**GROWTH MANAGEMENT DEPARTMENT STAFF REPORT**  
**SOUTH ANASTASIA OVERLAY DISTRICT**  
January 26, 2023 Public Meeting  
SADRB 2022-05 7740 A1A Offbeach Parking

**Summary of Request:** Applicant is requesting design approval for a proposed St. Johns County park with an associated parking lot and restroom facility with beach access. This review is specifically for the structures proposed for the site: the restroom facility, and the signage. The applicant has been requested to provide physical color/material samples at the hearing to assist in Board review. Staff notes that the proposed site plan meets all setback/buffering requirements for RS-2 zoning in the South Anastasia Overlay District, as well as impervious surface ratio and floor area ratio.

DRAWN BY:

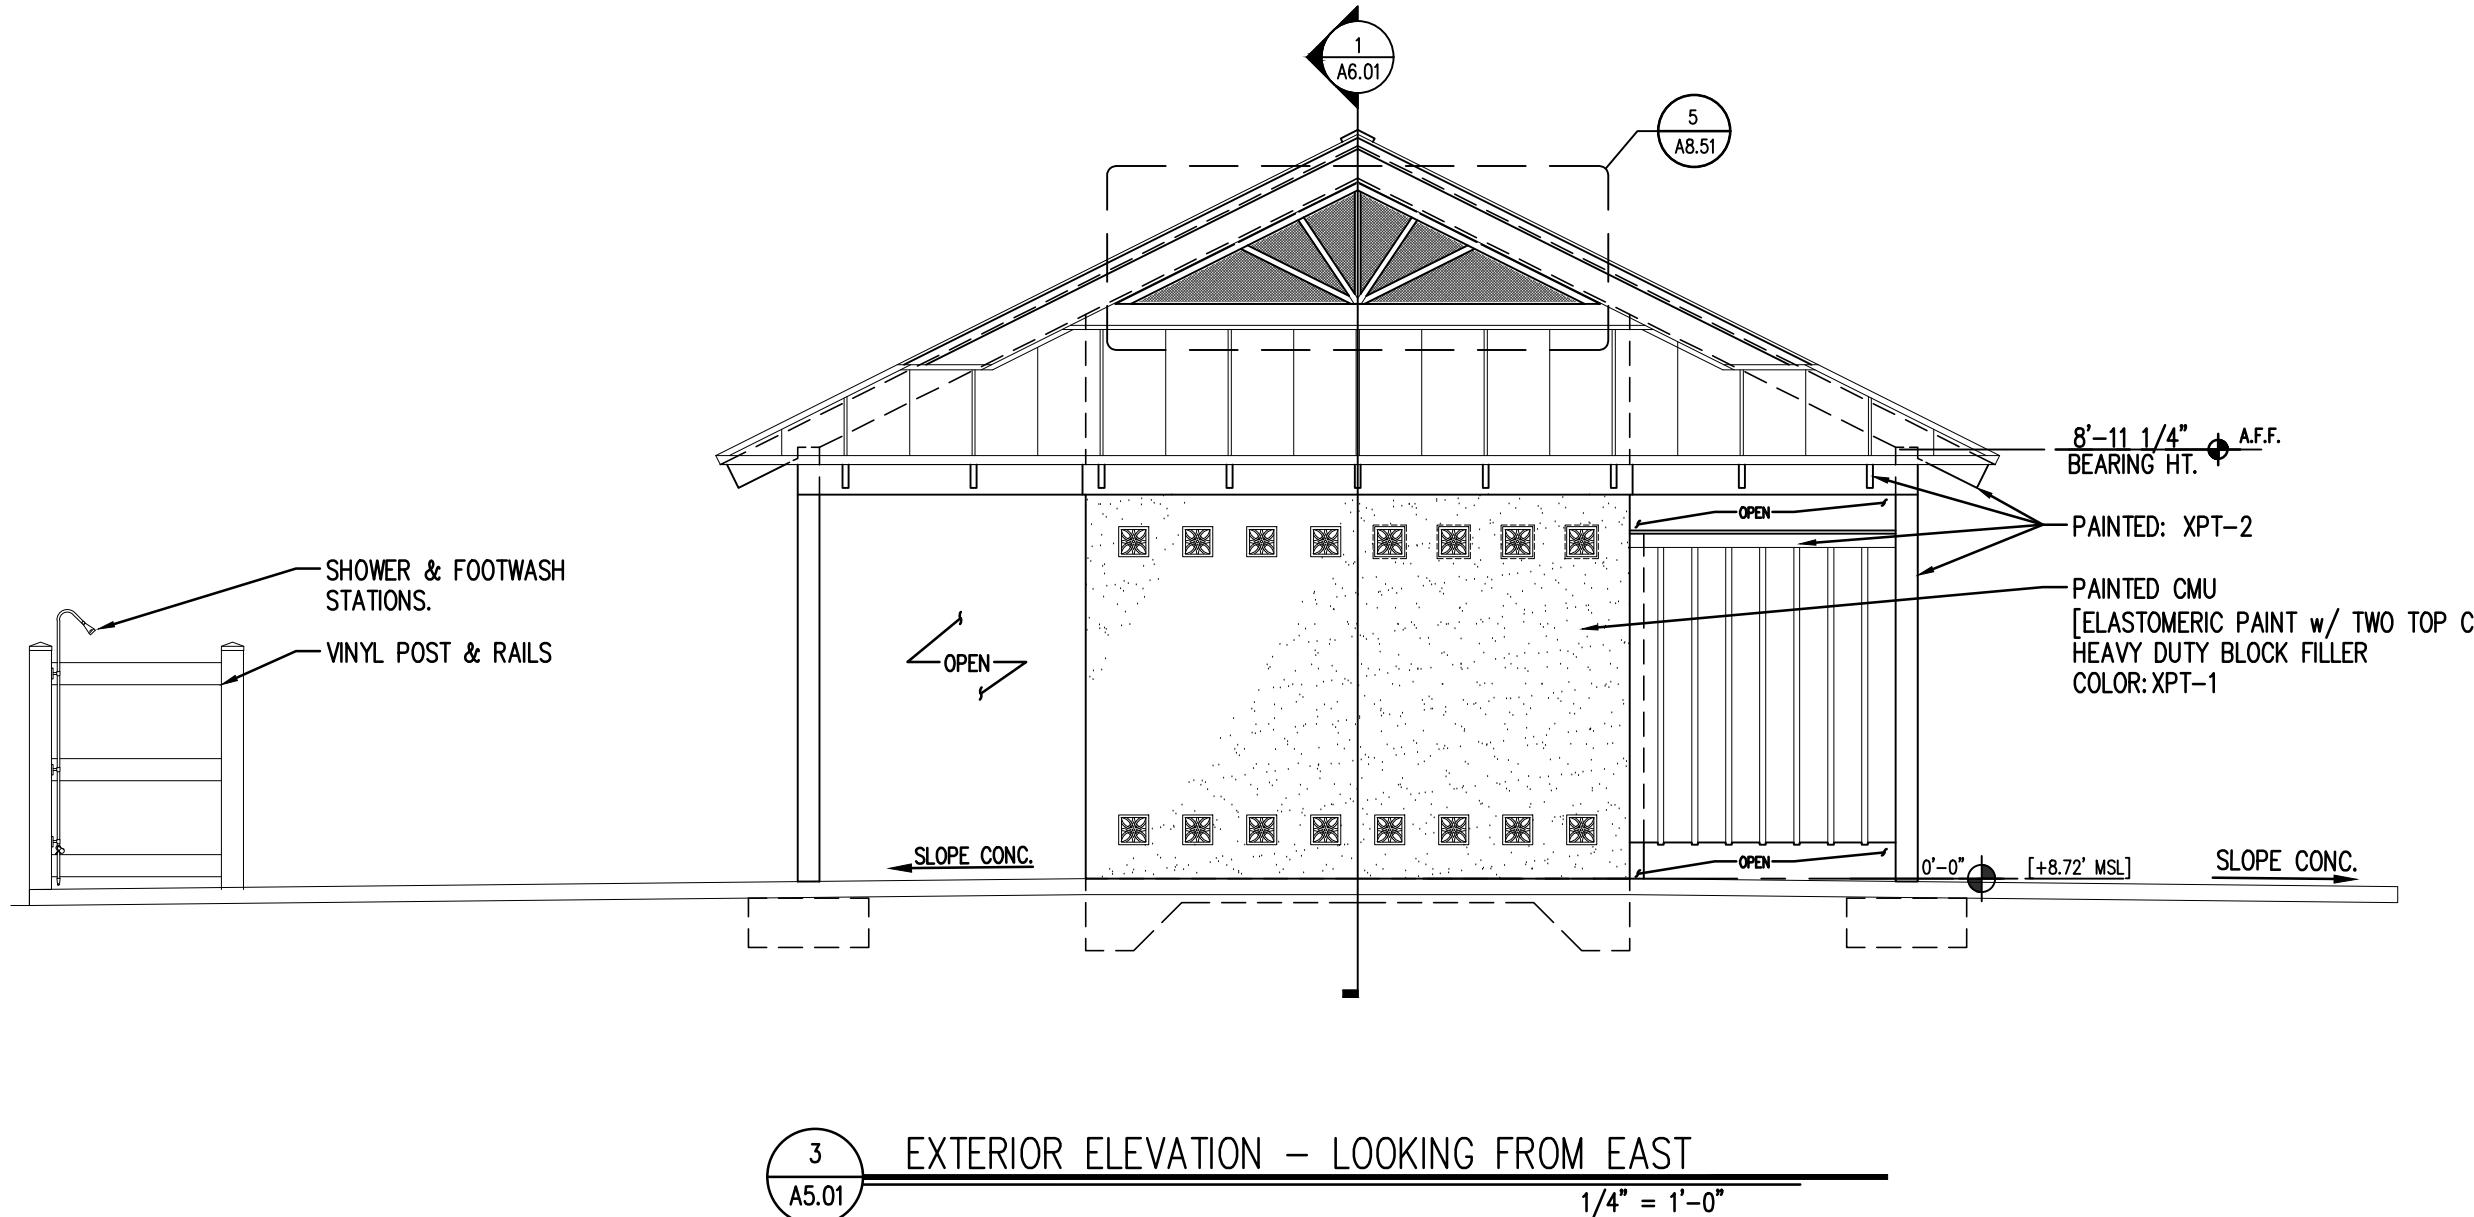
**Planning Division:** The roof design of the proposed bathroom/changing room structure appears to be consistent with LDC Section 3.07.04.A1. In regards to roof material, LDC Section 3.07.12 states, "Roof shall consist of wood or asphalt composition shingles, barrel tile, clay tile or similar non-reflective finished material having a natural texture and appearance. Metal roofs shall only be allowed where they are characteristic of a recognized architectural style." The proposed metal roof may be allowed if it is deemed characteristic of the "Old Florida" style. Additionally, the proposed color scheme appears to comply with the architectural design standards in the "Old Florida" style as set forth in LDC Section 3.07.11.

1 ENTRY SIGNAGE DETAILS  
A1.04 3/4" = 1'-0"

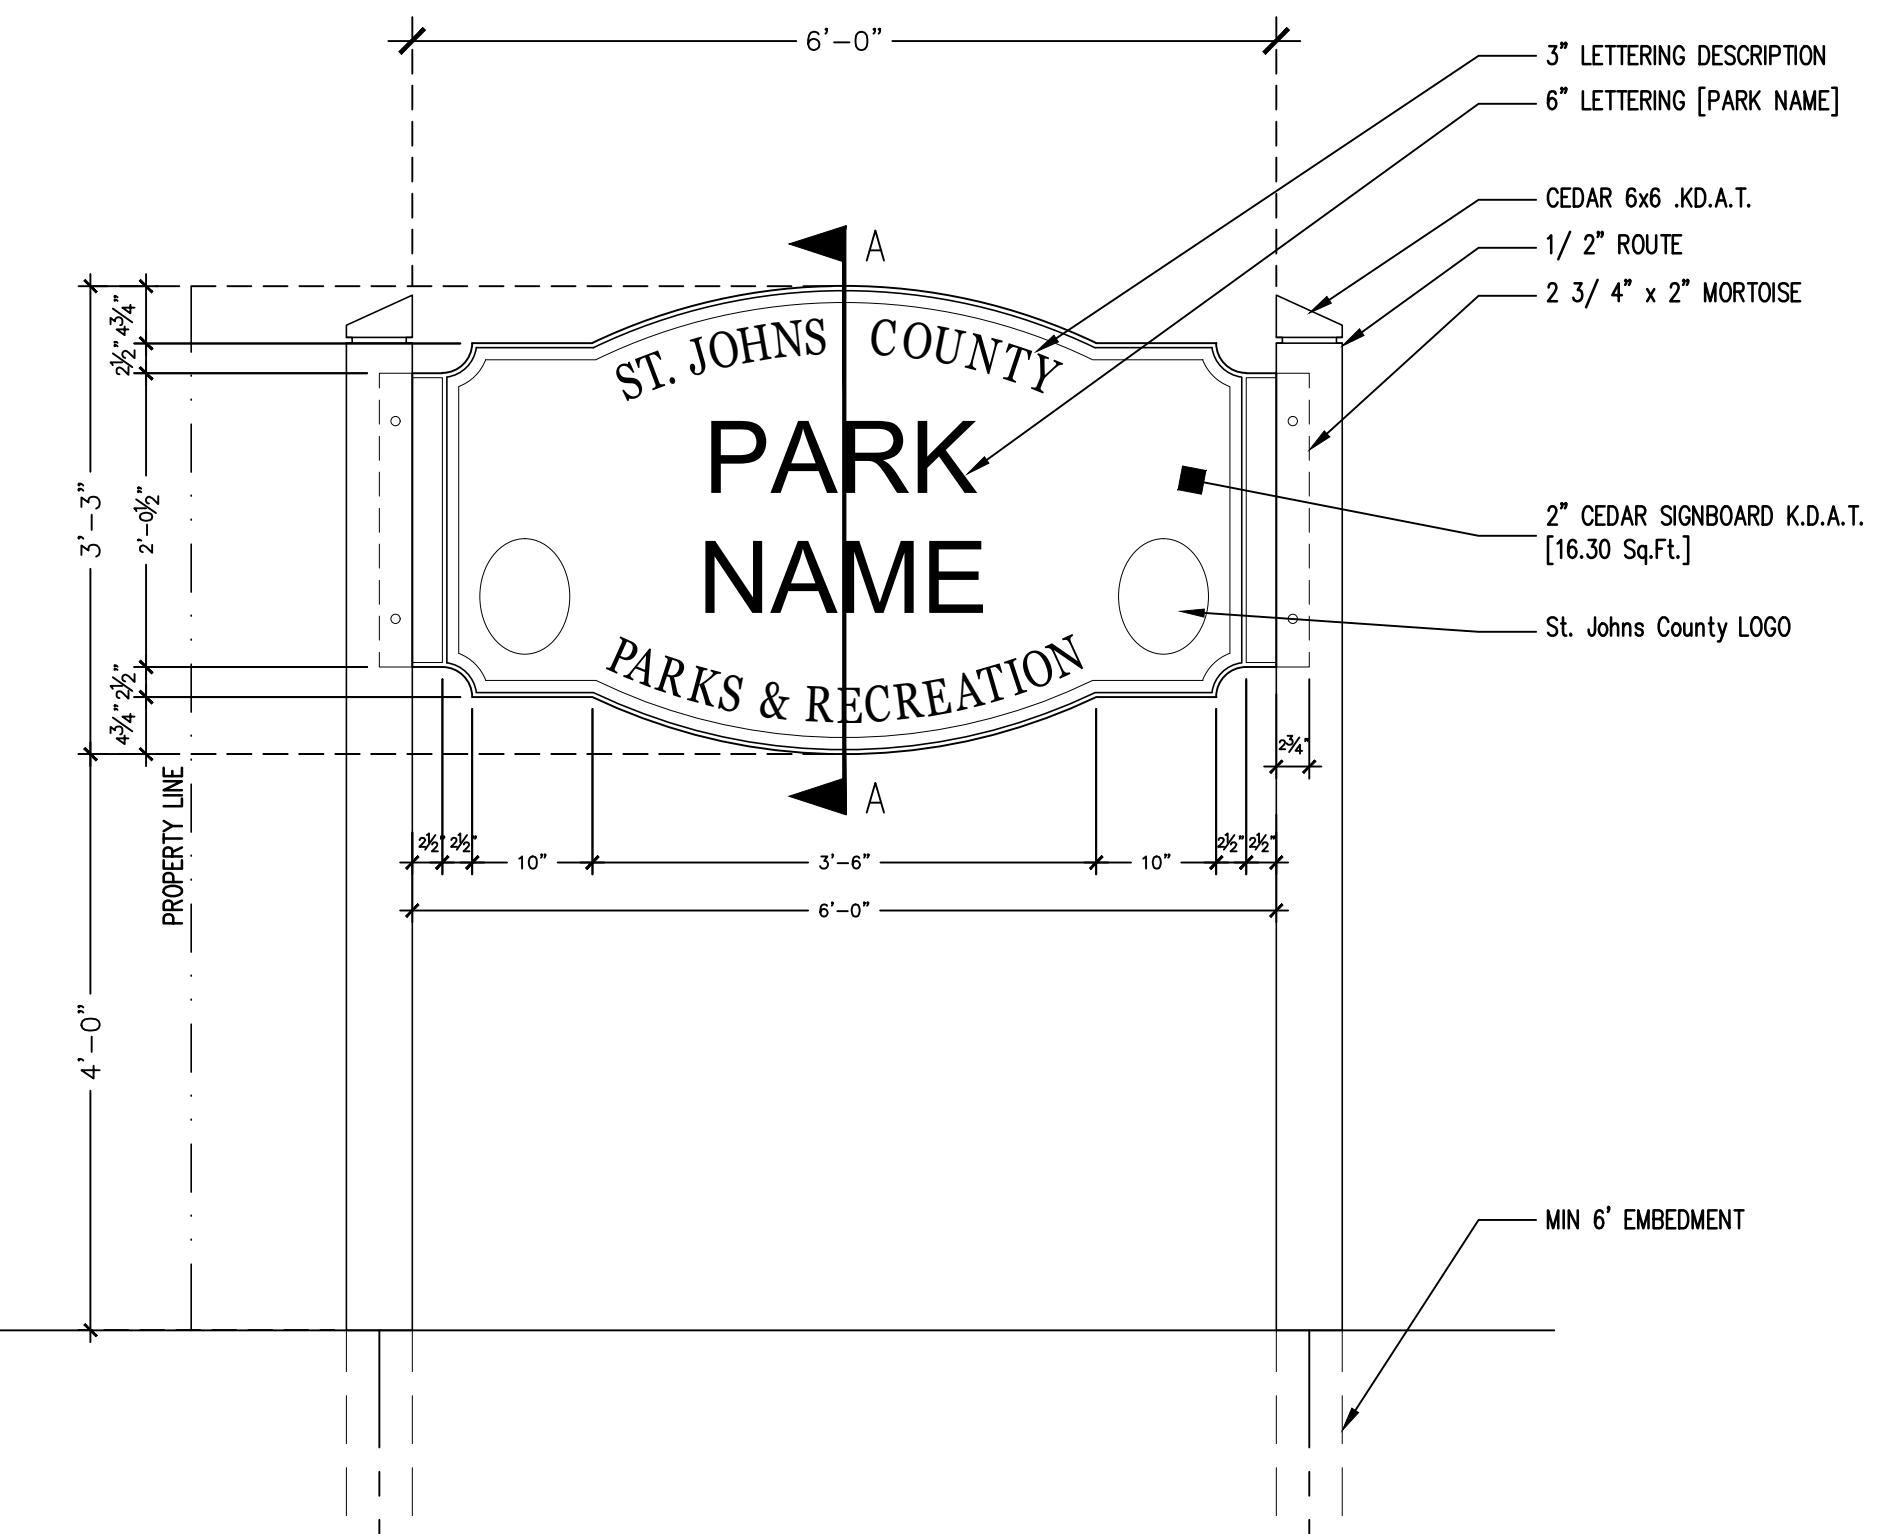
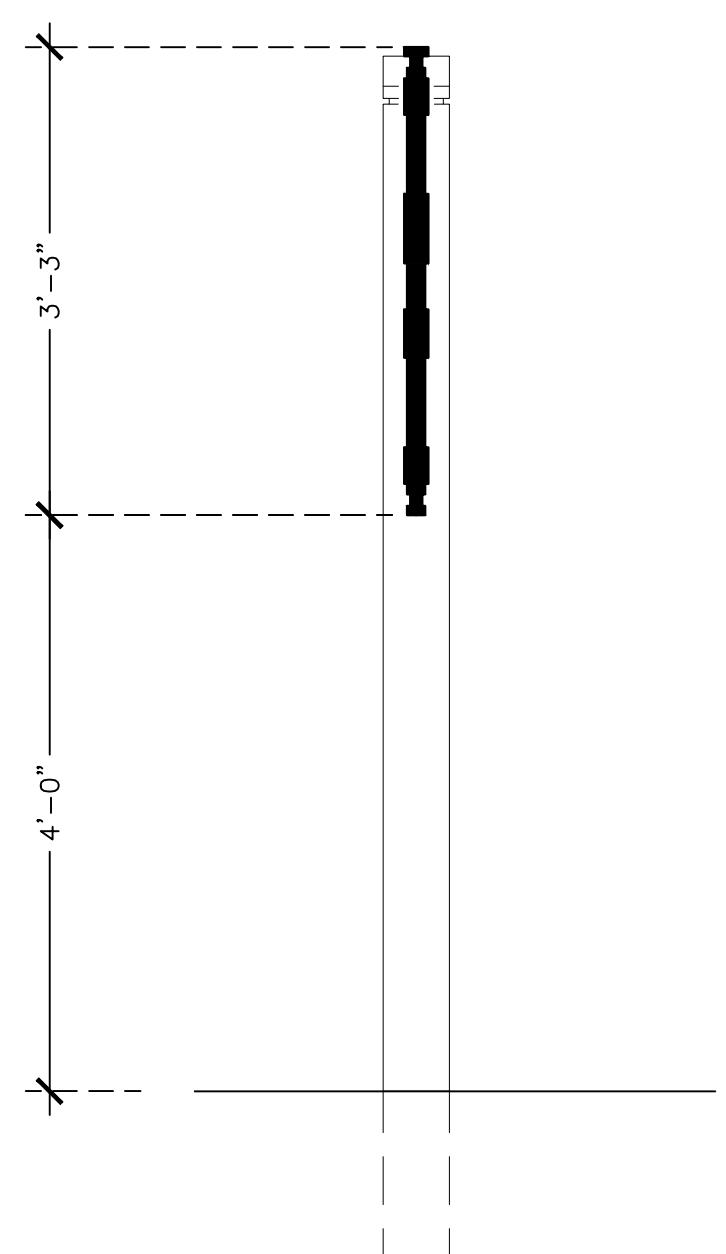
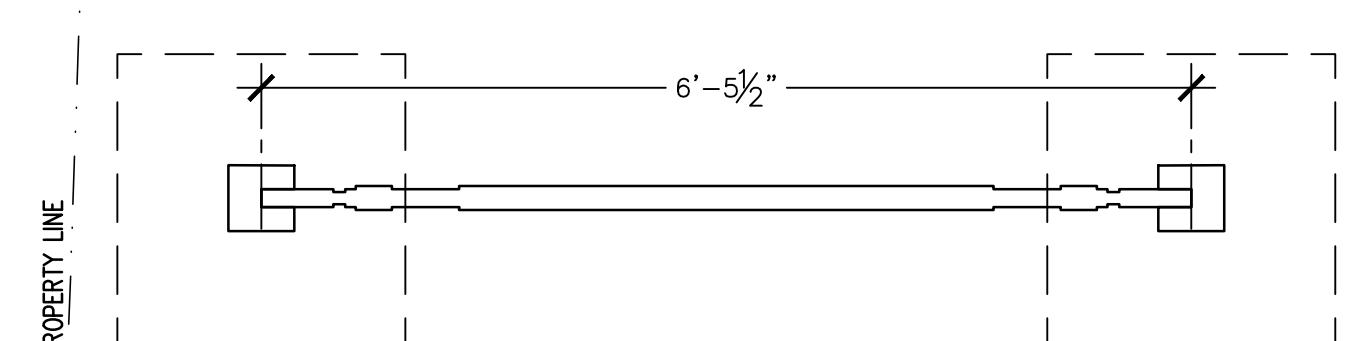
Staff notes that the signage is proposed to match other St. Johns County park signs that can be seen throughout the county. The only difference will be the park name. Please see attached drawings for proposed sign colors.

The proposed signage has approximately 18 sf of ADA. This is in compliance with the allowed maximum of 32 sf. Wide-based monument signs are preferred per LDC Section 3.07.09.A, however, alternatives are allowed at the discretion of the DRB.
